CROSSROADS NORTH PRELIMINARY PLAN

LOCATED IN THE EAST 1/2 OF SECTION 8, T14S, R65W, OF THE 6th P.M., EL PASO COUNTY, COLORADO

Prelim Plan V_1 redlines.pdf Markup Summary 12-18-2020

CROSSROADS NORTH
PRELIMINARY PLAN

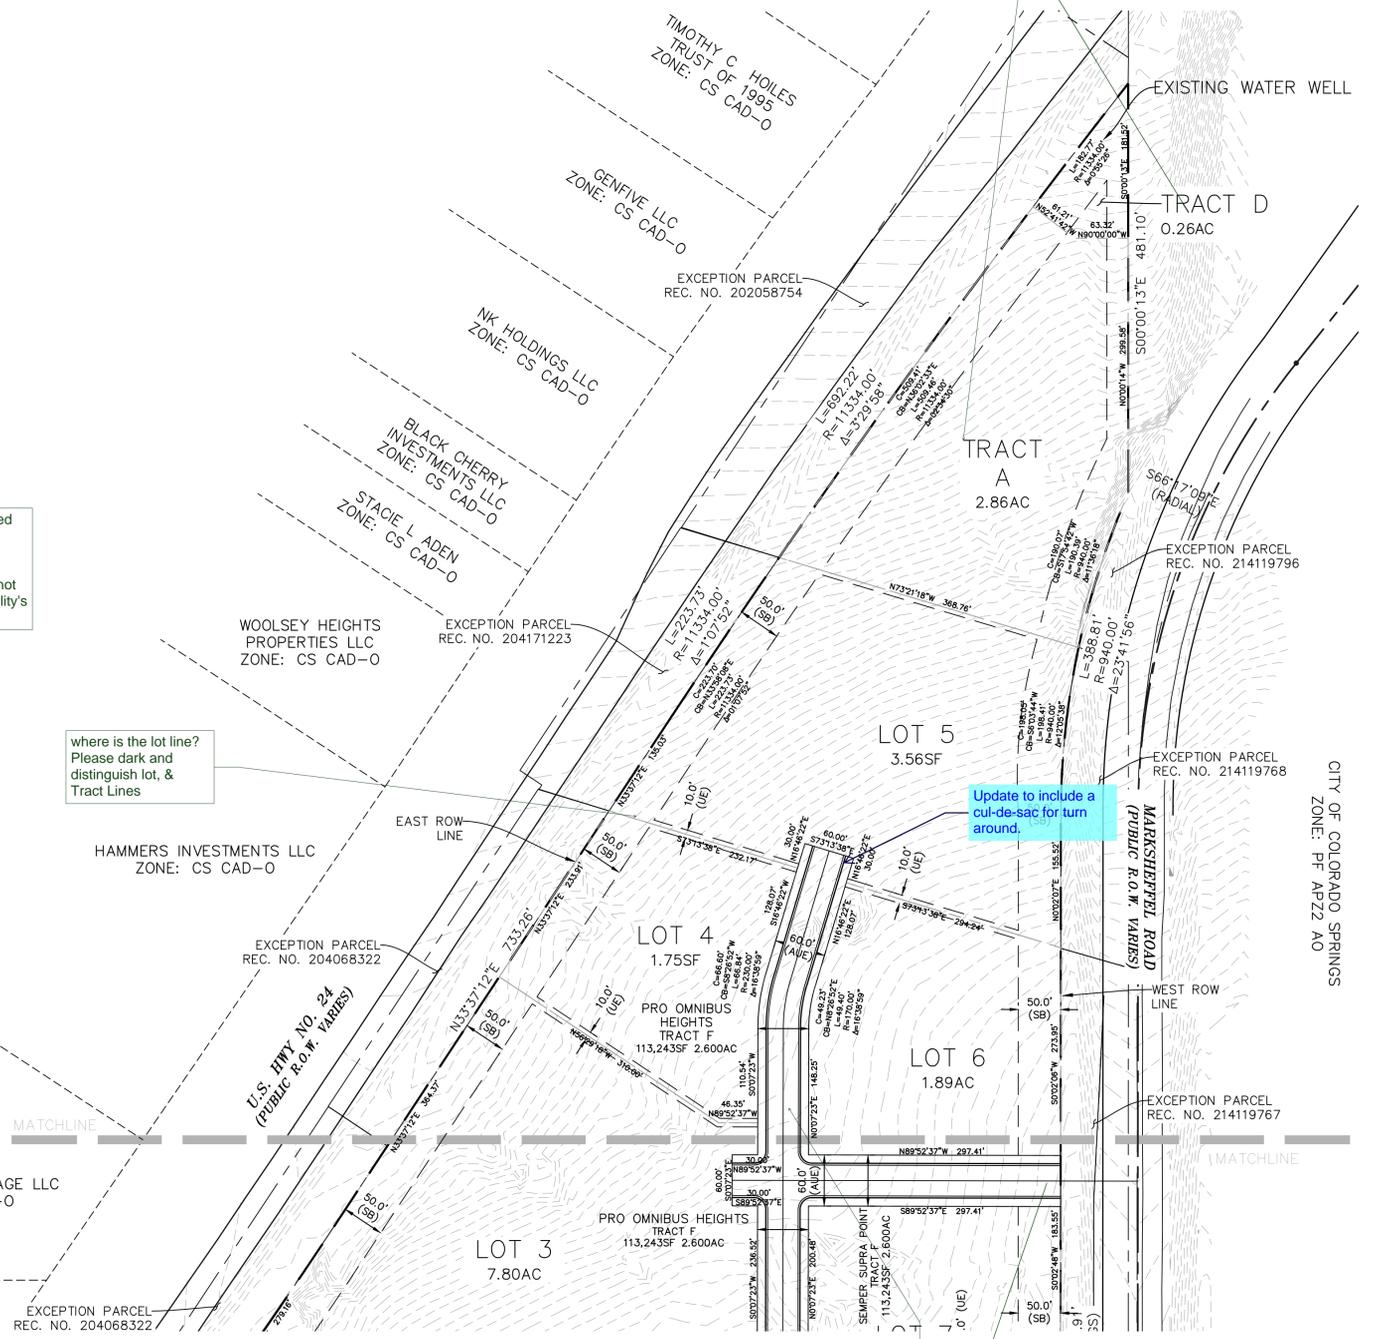
one lot table per prelim plan please....we do not need to repeat information.

state what the these tracts purposed for? are any future development? Tracts shown in Drainage report clearly are not intended for pedestrians to walk about it so its not landscape / openspace and are utility's in the drainage tracts allowed ?

if one drives on it its not open space/ landscape- is also likely not a drainage pond

Crossroads Metro District 2- correct? identify name at least once...

please specifically show trails/sidewalks in tracts that are specifically for pedestrian facilities- i don't think thats the case for all tracts? Are here sidewalks adjacent to private road tract or within them?

there are multiple checklist items missing- please add.

what tract is this? all tracts and lots must have a closed boundary, distance, bearings, SF, shall be shown for each. put label in side so we know which segment is which please..

identify sheet name used on index

CROSSROADS NORTH
PRELIMINARY PLAN

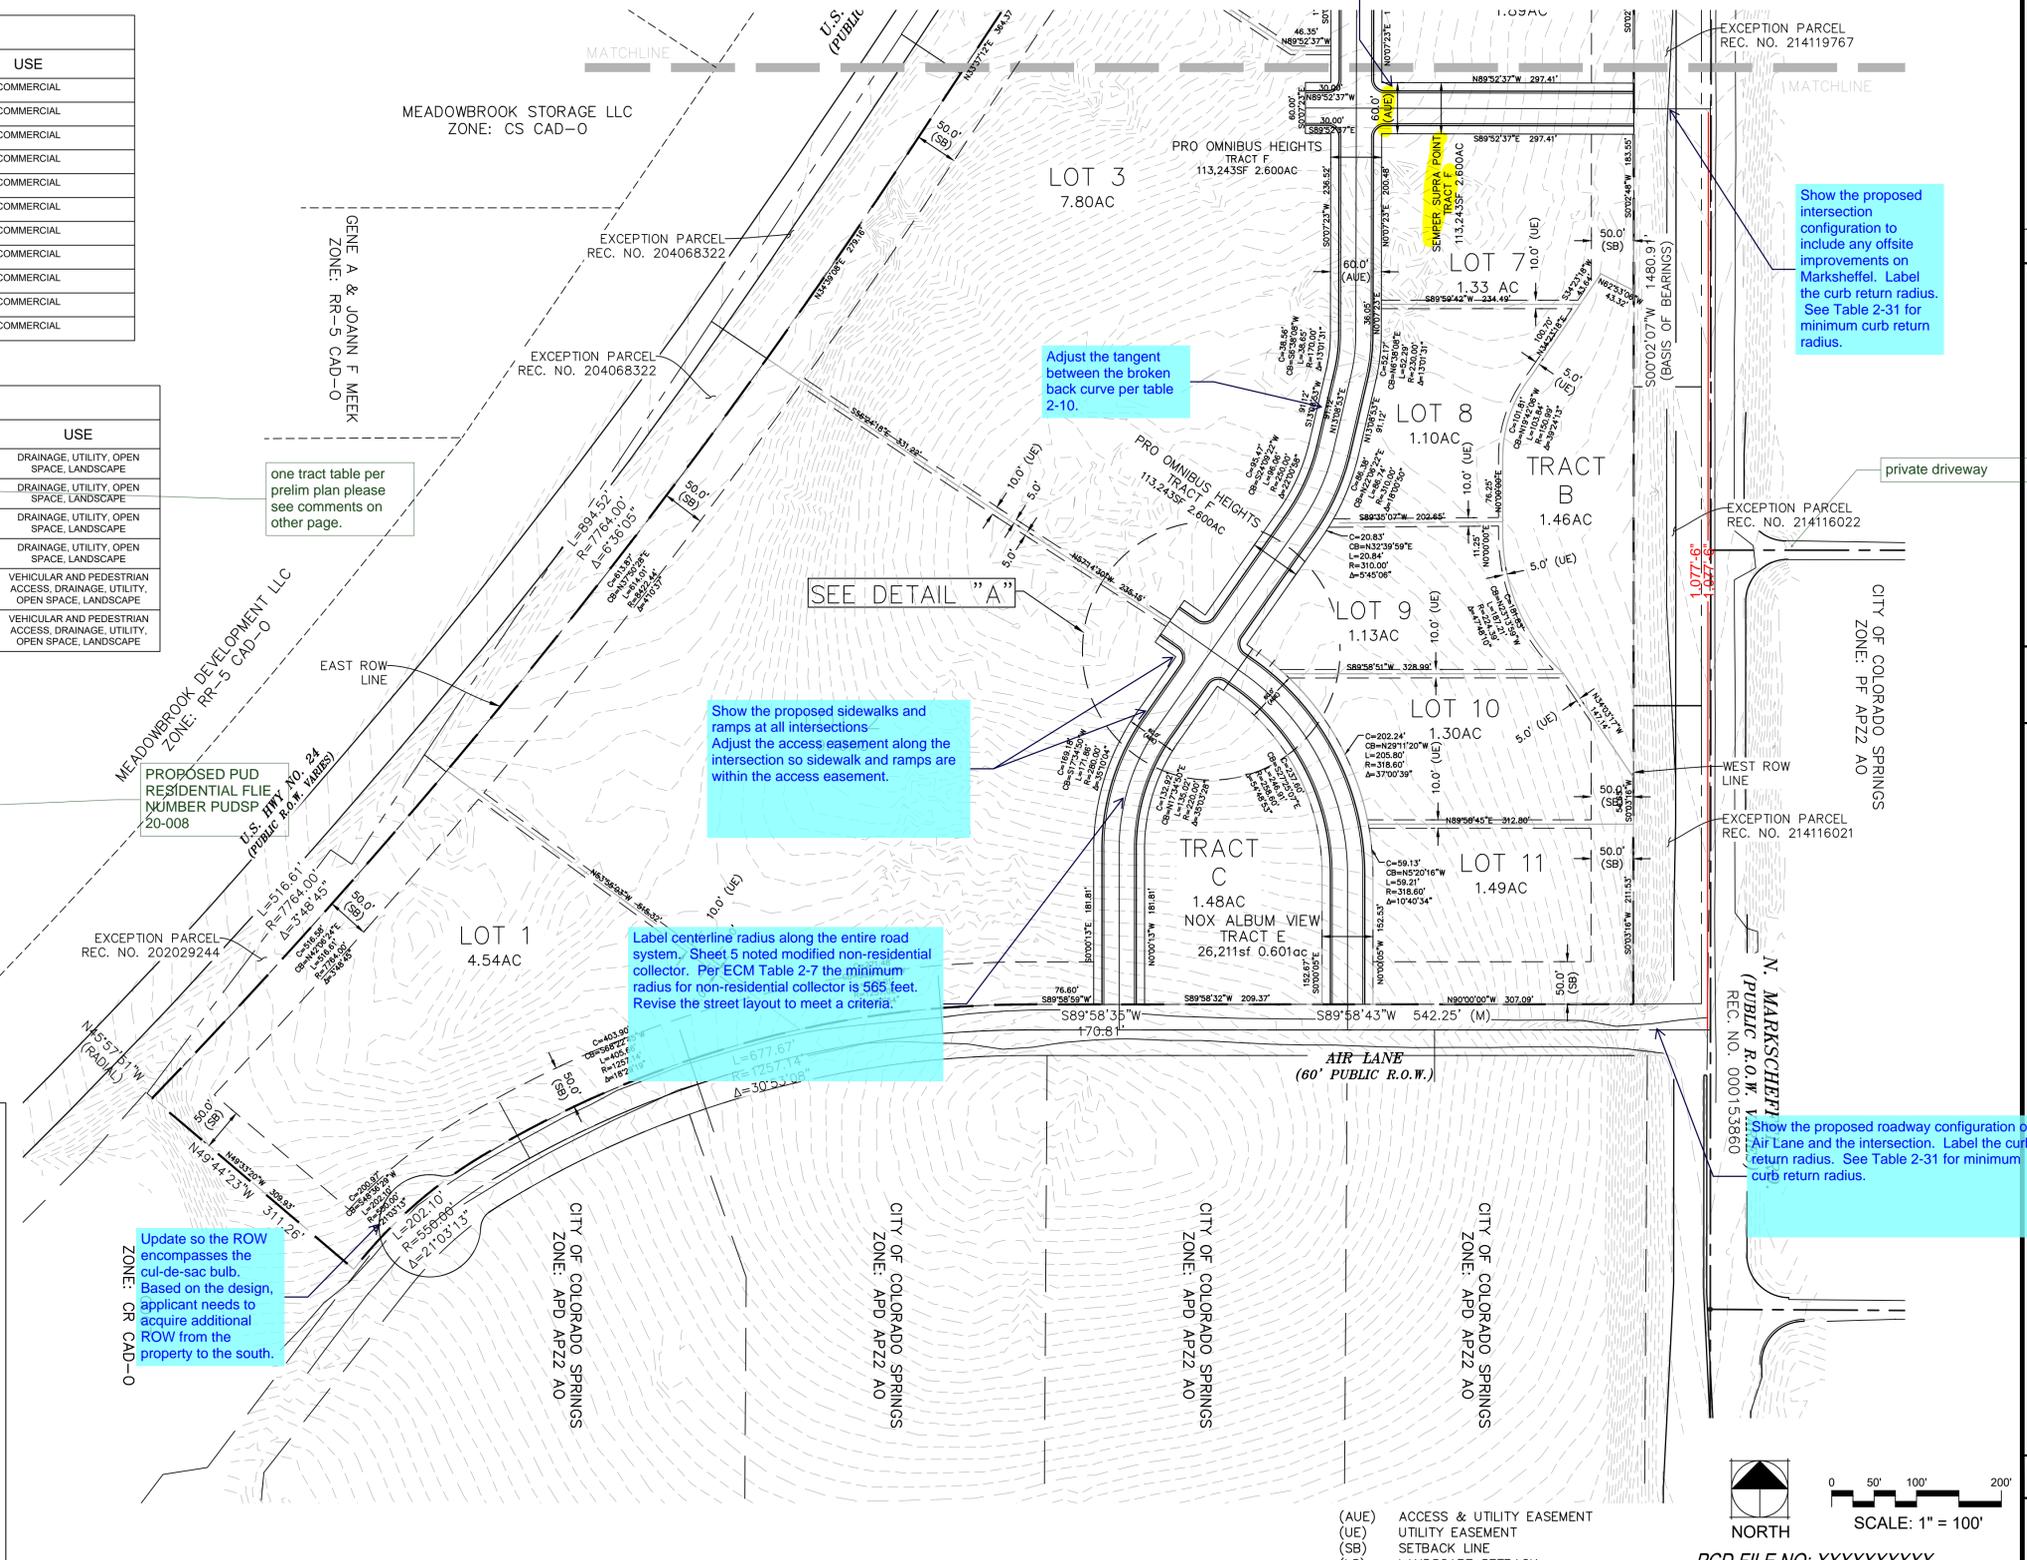
This appears contradictory. The roads are both identified as tract and easement.

Show the proposed intersection configuration to include any offsite improvements on Marksheffel. Label the curb return radius. See Table 2-31 for minimum curb return radius.

Adjust the tangent between the broken back curve per table 2-10.

one tract table per prelim plan please see comments on other page.

Show the proposed sidewalks and ramps at all intersections. Adjust the access easement along the intersection so sidewalk and ramps are within the access easement.

Label centerline radius along the entire road system. Sheet 5 noted modified non-residential collector. Per ECM Table 2-7 the minimum radius for non-residential collector is 565 feet. Revise the street layout to meet a criteria.

Update so the ROW encompasses the cul-de-sac bulb. Based on the design, applicant needs to acquire additional ROW from the property to the south.

Show the proposed roadway configuration of Air Lane and the intersection. Label the curb return radius. See Table 2-31 for minimum curb return radius.

CROSSROADS NORTH PRELIMINARY PLAN / LANDSCAPE STANDARDS

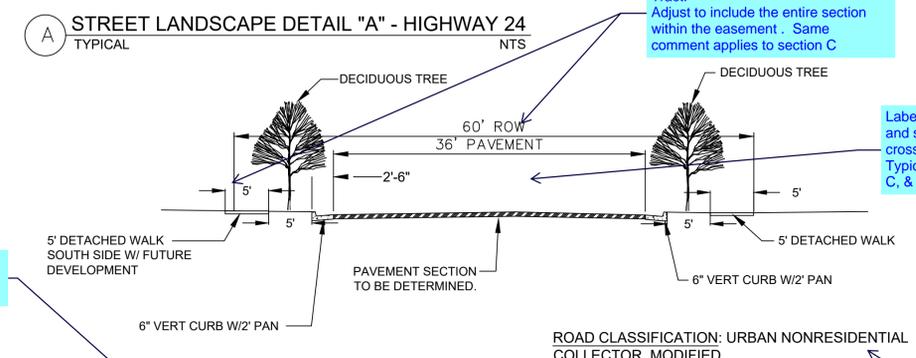
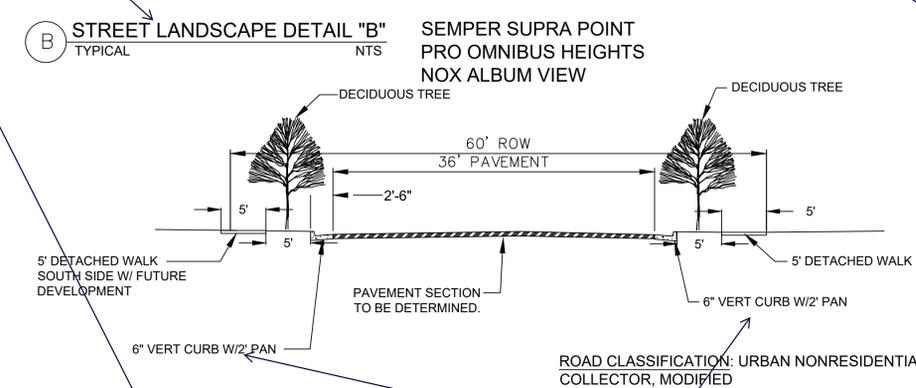
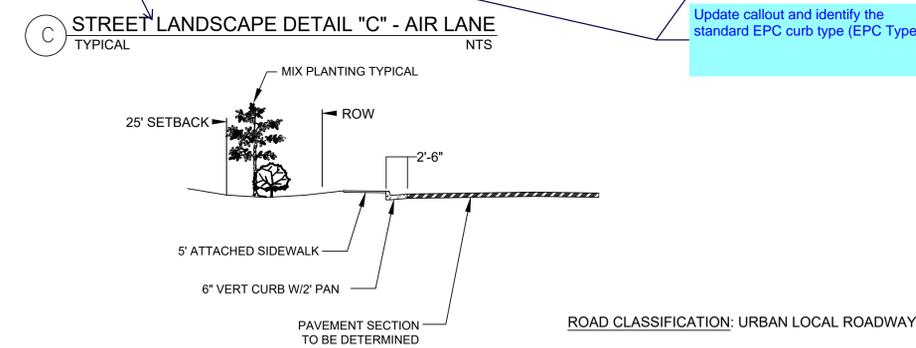
where is the exhibit showing the street trees? please provide and verify line of sight/sight triangles are shown...if Developer is installing with development...if you want to enforce standards shown in details

Change from ROW to either AUE or Tract. Adjust to include the entire section within the easement. Same comment applies to section C

Label lane widths and street/sidewalk cross slopes. Typical for sections B, C, & D

Update Sections B, & C by inserting the word "and" between street landscape.

This requires deviation request from the standard urban non-residential collector cross section. Same comment applies to Section C

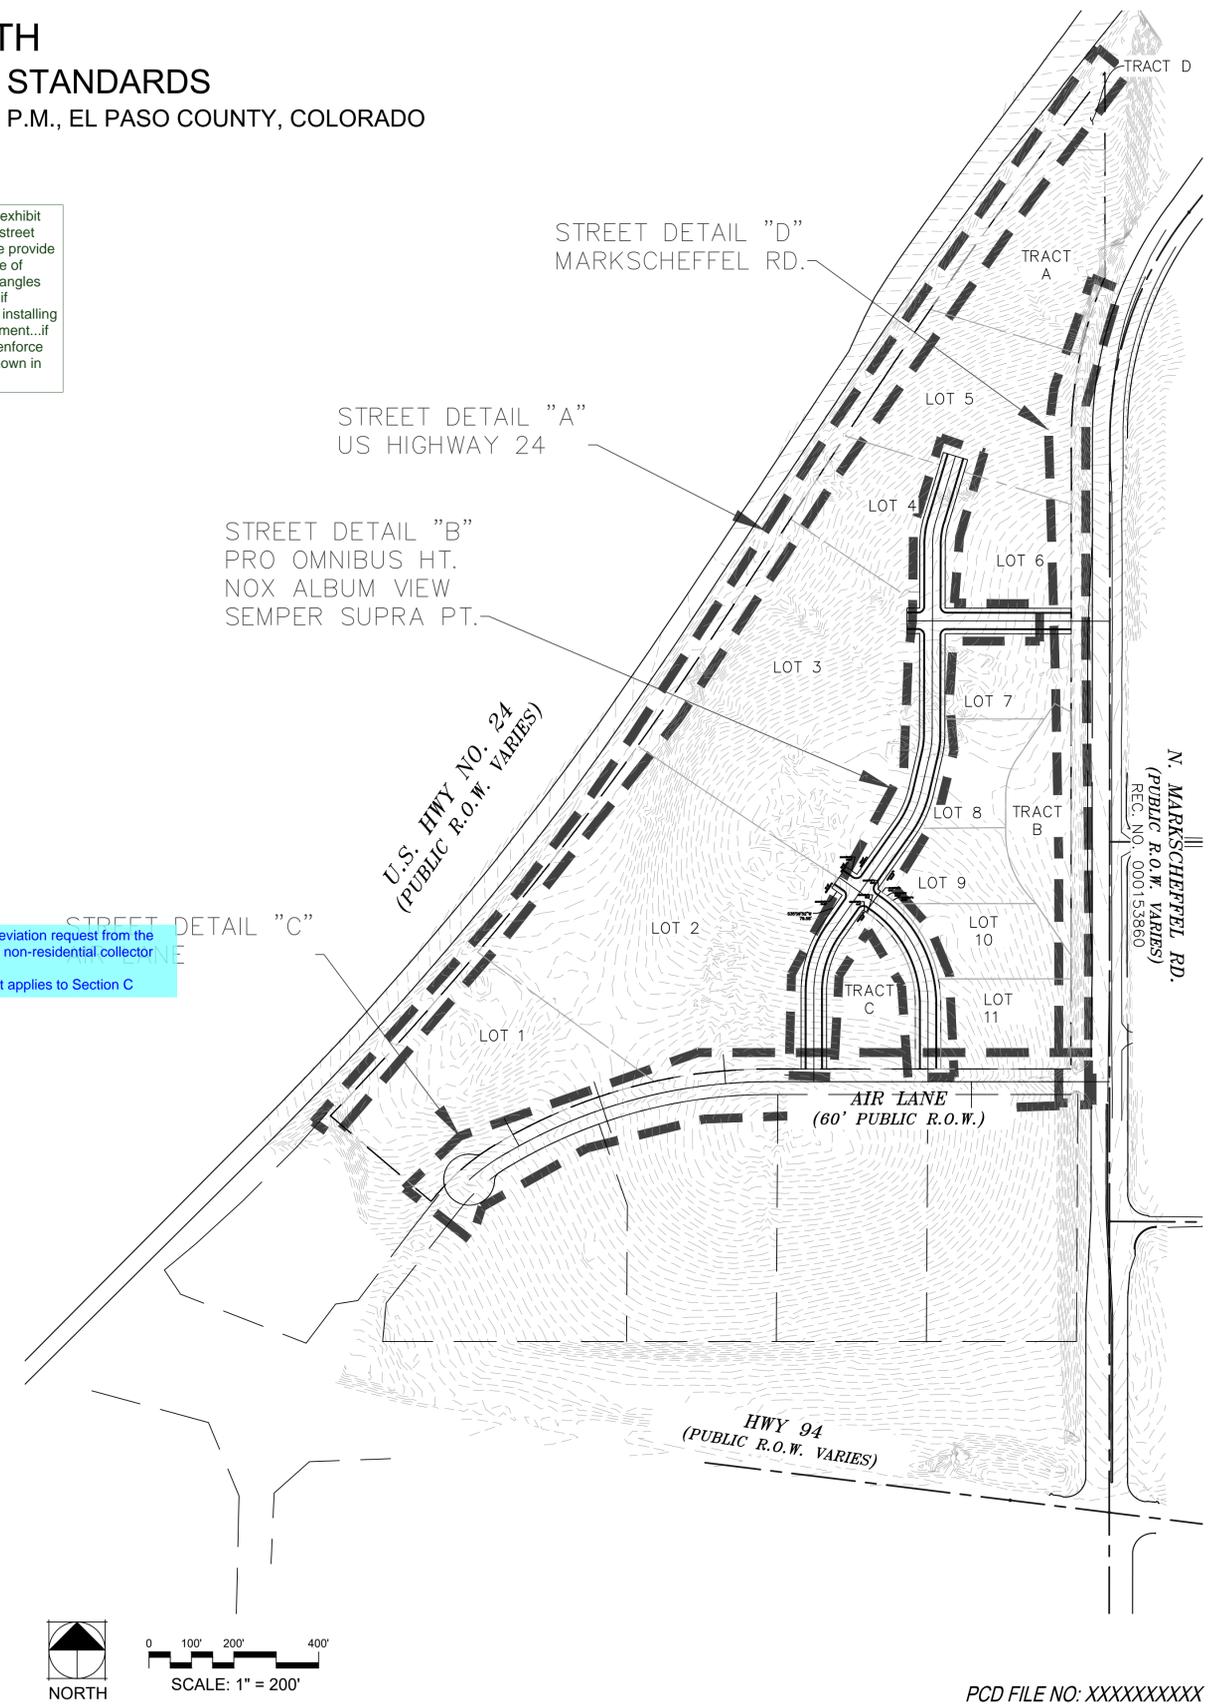
Update callout and identify the standard EPC curb type (EPC Type A)
